**RE: Repair Permit Denial**  
Township/Range/Section: T4N, R10W, S18BB; Tax Lot No. 1400 (via easement onto Tax Lot No. 1200), Clatsop County

Subject: Engineering geologic site stability review,  
Tax lot 1200, Map 4N 10W 18BB,  
Lot 3, Block 1, Noriston Park, Arcadia Beach  
Clatsop County, Oregon

Re: On-Site Sewage Disposal  
John Chaney (Owner)  
T.4N., R.10W., Sec.18BB Tax Lot 1400  
Clatsop County  
**Major Repair Permit Application**

Figure 1. Enlargement of ODOT aerial photograph CLB-31 1-3, 1975.

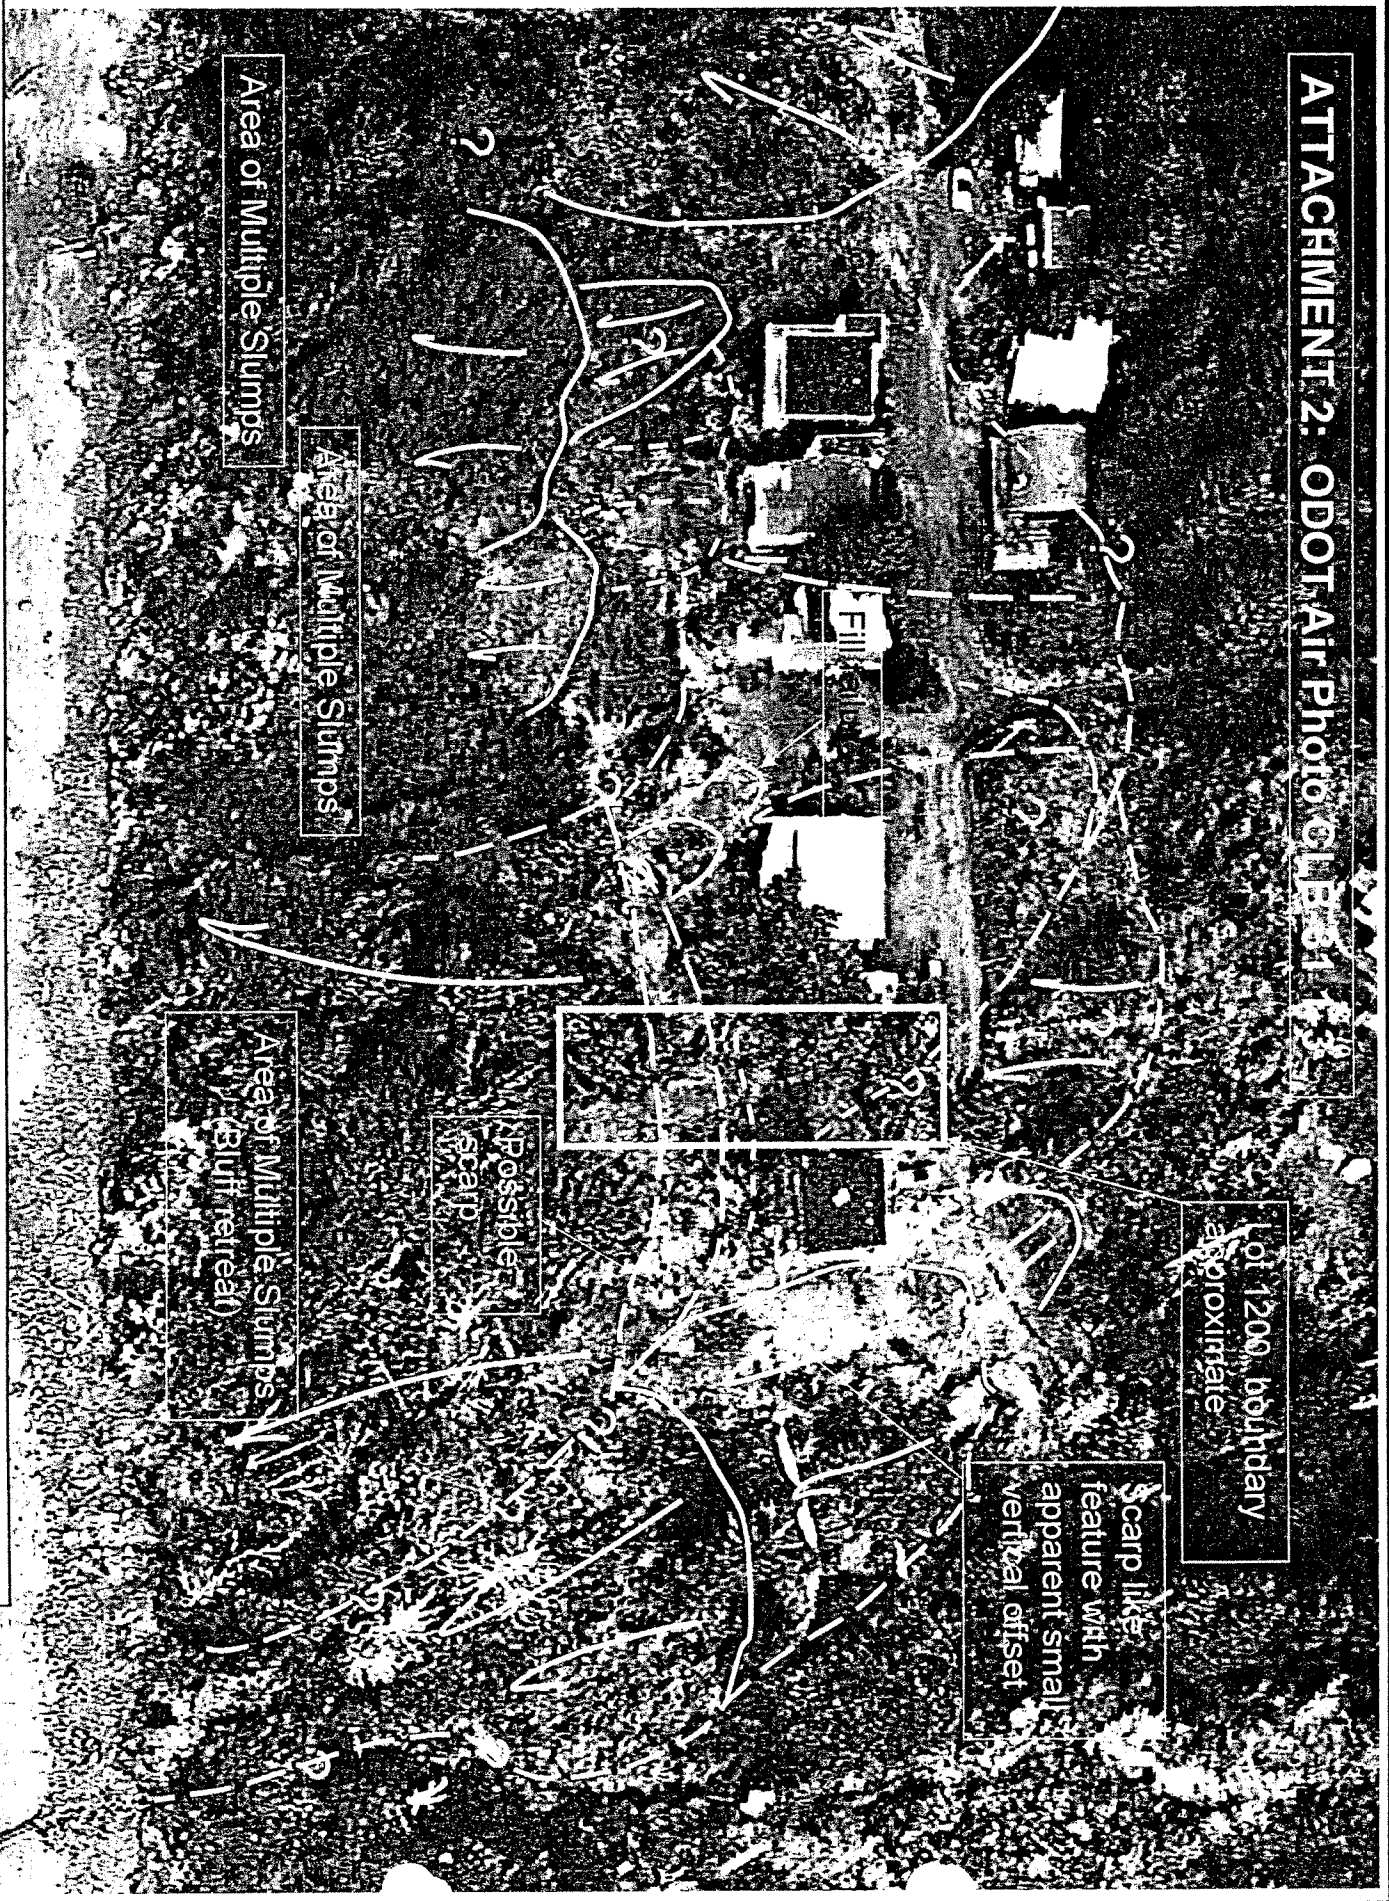
- Figure 1 represents an enlargement of ODOT aerial photograph CLB-31 1-3 taken in 1975.
- Figure 2 represents geomorphic features that indicate the adjoining properties are likely underlain by unstable landforms and, at a minimum, a portion of the subject lot may also be underlain by an unstable landform. The approximate location of the subject lot is shown on the enlarged image. Applying indicator parameters for recognition of landslide geomorphology, the following was observed:

- Several "stepped" breaks in the slope were observed between the beach and the top of slope west of the subject lot and west of the adjacent lots. These breaks appear to represent landslide slump blocks that individually have a limited lateral displacement, but cumulatively can represent a large lateral displacement. The initiated failure mechanism is likely wave action erosion in combination with other factors such as groundwater elevation and/or degree of soil saturation. Typically, the lowest block fails, reducing resisting force for the next block, which then fails. The process continues until the overall slide complex self-stabilizes, i.e. resisting forces become equal to driving forces Factor of Safety (FS) equals 1. The geomorphic indicators observed in the stereoscopic pairs of aerial photographs support the stepped mass wasting landslide process.

- An arcuate break in slope transects the lot to the south and the western portion of the subject lot. The break in slope is most likely less than a few feet in vertical height. The west side appears down-dropped relative to the east side. This feature is consistent with observed scarps associated with landslides on adjacent properties. It is also consistent with approximate location of the inferred easternmost failure surface shown on the geologic cross-section in the geohazard report. However, other explanations for this feature may be possible such as a cut made during past logging practices in the area; and
